Your Ref
WA/62/18/PL
Our Ref
PLAN-024029
Date
23/08/2018

Proposal: Continuation of A1 showroom use following 2-year temporary permitted development. This application affects the character and appearance of Walberton Conservation Area.
Site: The William Booker Yard, Unit E1 The Street Walberton BN18 0PF.
WA/62/18/PL

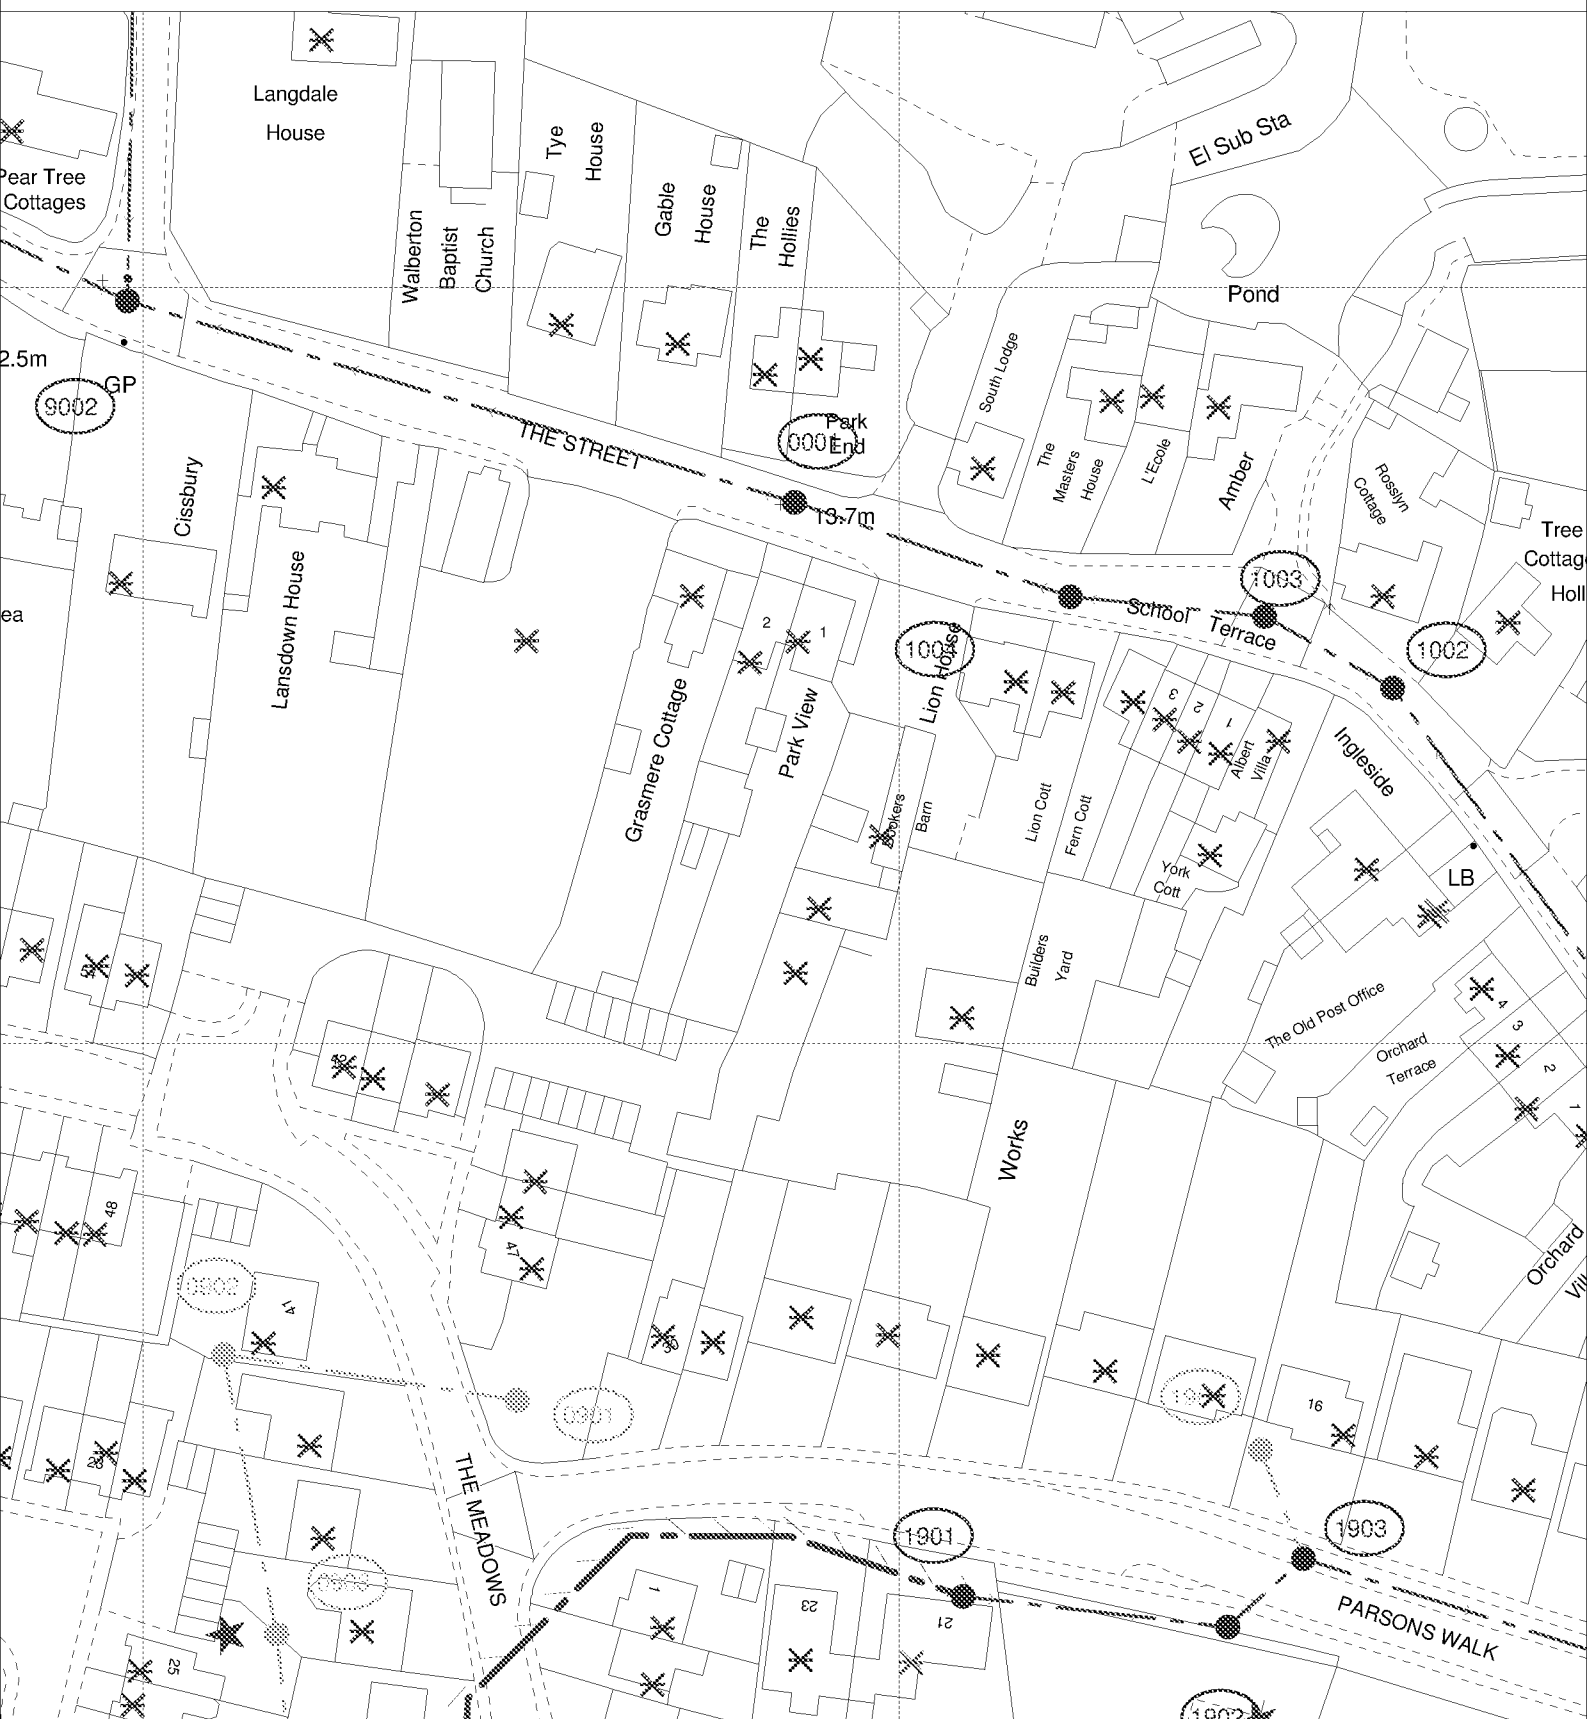
Due to surface water inundation issues in the Lidsey Catchment "The applicant is advised to adopt, where appropriate, the measures in the table "Practical measures to reduce the potential impacts of development".

Developer should look to protect the public sewerage system from inundation and infiltration, which contribute to flooding in unfavourable conditions.
